Wisconsin Department of Transportation

Proposal #13: 1310-18-70, WISC 2021 141
Lake Geneva – Kenosha
CTH O – STH 75, 236th Ave – 125th Ave
STH 50
Kenosha County

This is Addendum No. 01, which provides for the following:

Addendum No. 01
 ID 1310-18-70
 Revised Sheet 116
 February 4, 2021

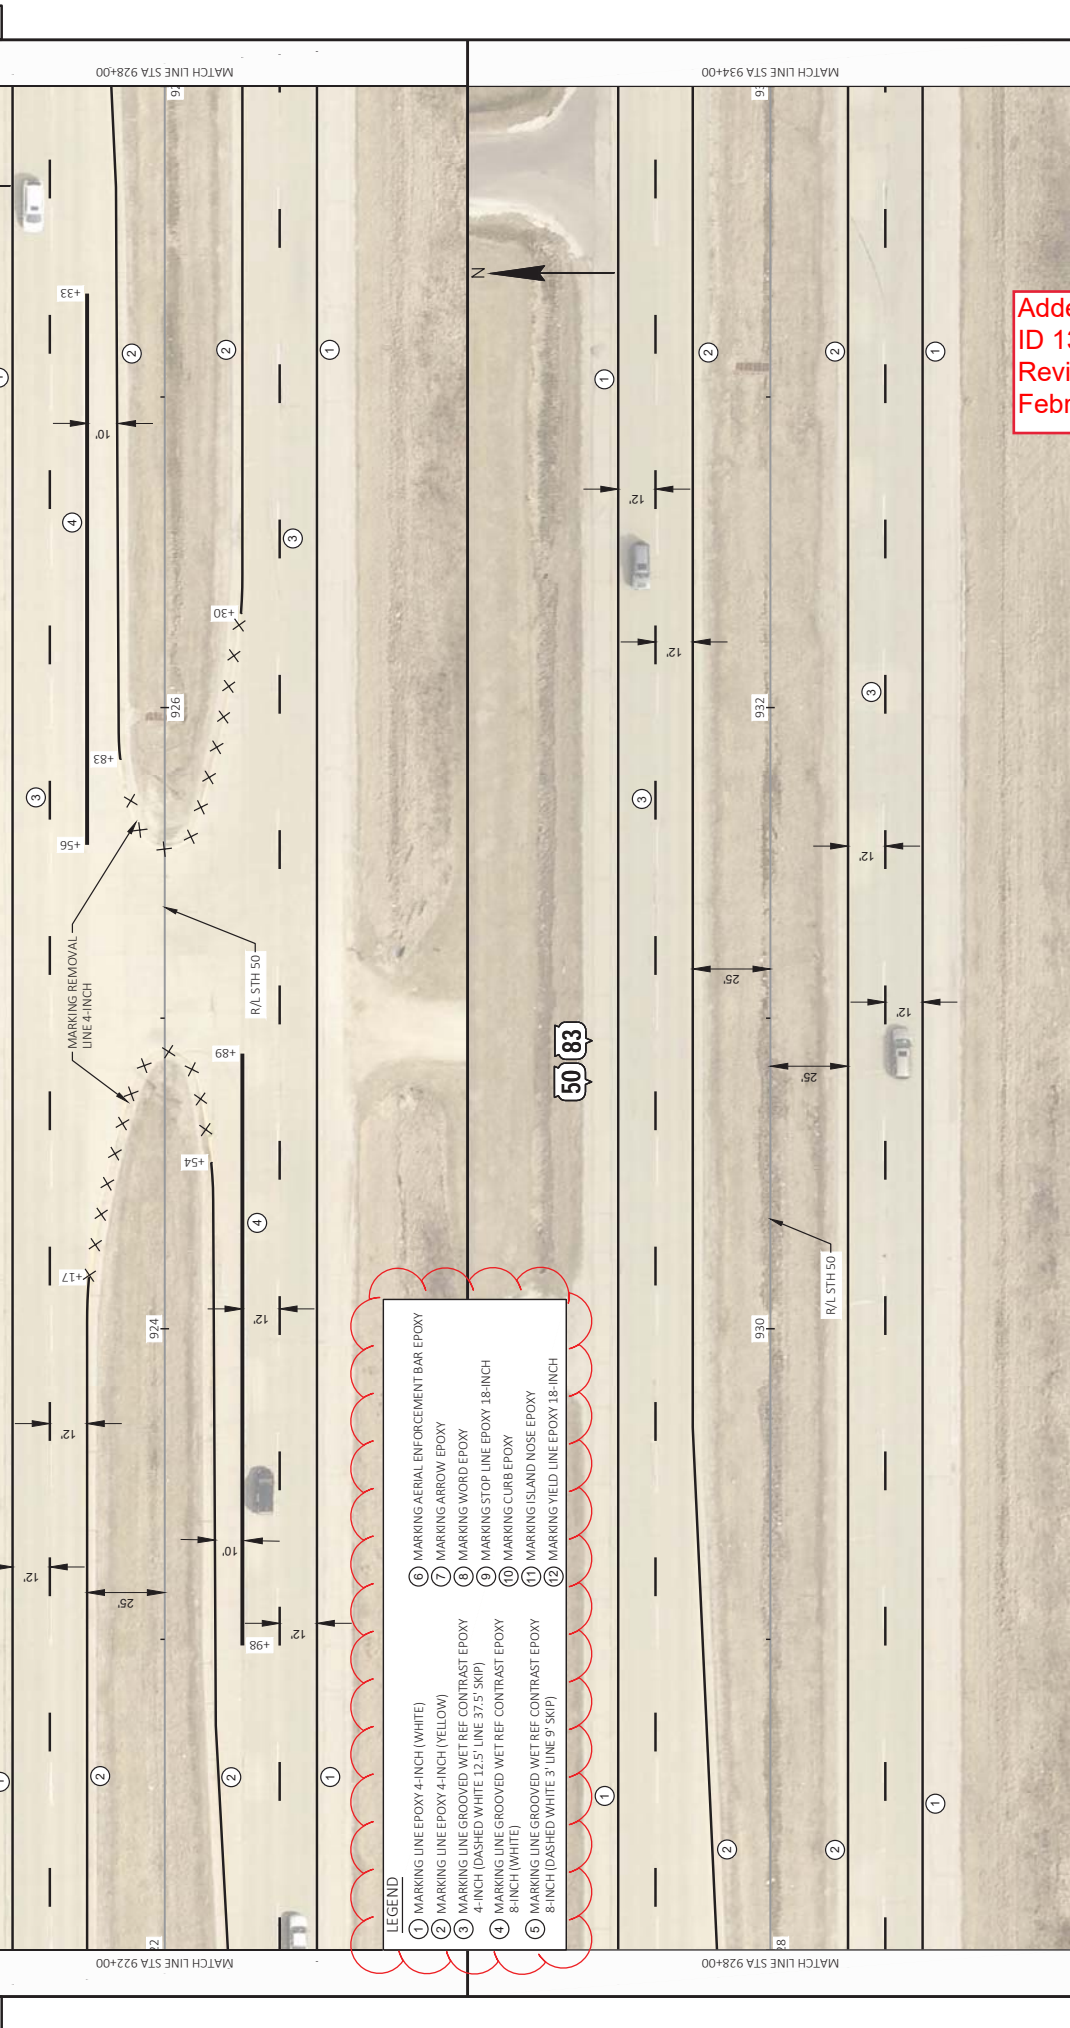
Revised Plan Sheets	
Plan Sheet	Plan Sheet Title (brief description of changes to sheet)
93-164	Pavement Marking: Changed items 1 and 2 in legend and callouts on pages 116 and 117.
234	Miscellaneous Quantities: Added marking items and consolidated Cold Weather Marking quantities into one column, the total did not change.
